Product Change Notification / MFOL-02RMEZ001

CCB 5351 Initial Notice: Qualification of MMT as an additional assembly site for PAC1710-1-AIA-TR, PAC1720-1-AIA-TR, and PAC1921-1-AIA-TR catalog part numbers (CPN) available in 10L VDFN (3x3x0.9mm) package.

Pre and Post Change Summary

MICROCHIP
QUALIFICATION PLAN SUMMARY

LEADFRAME COMPARISON

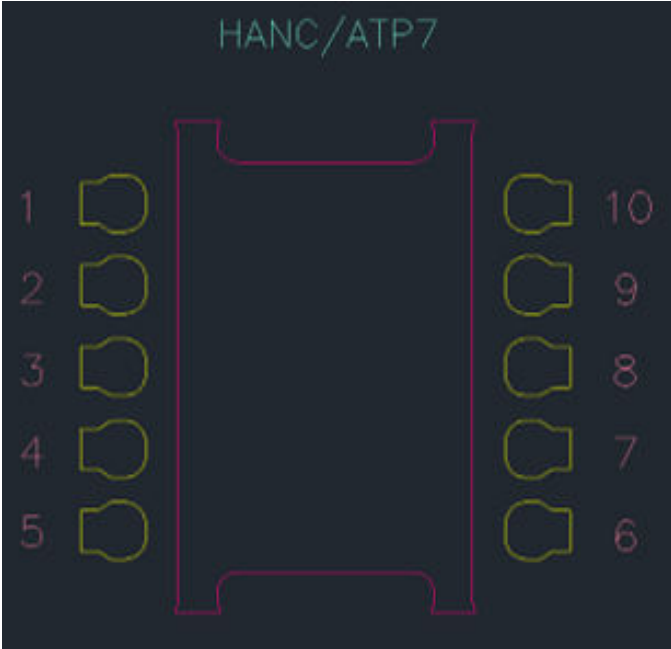
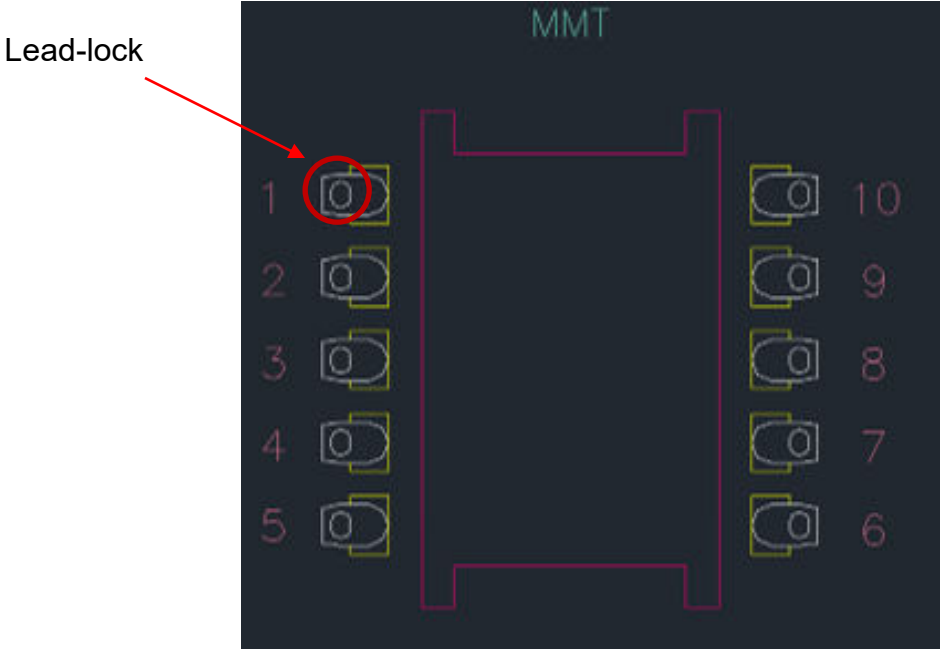
HANC / ATP7	MMT

<table><tr><td>Lead-lock</td><td>No</td></tr><tr><td>Lead frame Material</td><td>C194</td></tr></table>	Lead-lock	No	Lead frame Material	C194	<table><tr><td>Lead-lock</td><td>Yes</td></tr><tr><td>Lead frame Material</td><td>A194</td></tr></table>	Lead-lock	Yes	Lead frame Material	A194
Lead-lock	No								
Lead frame Material	C194								
Lead-lock	Yes								
Lead frame Material	A194

Note: Mold compound materials fills the leadlock hole, which provides improved protection against moisture penetration along the edge of the leads (pins) of the package.
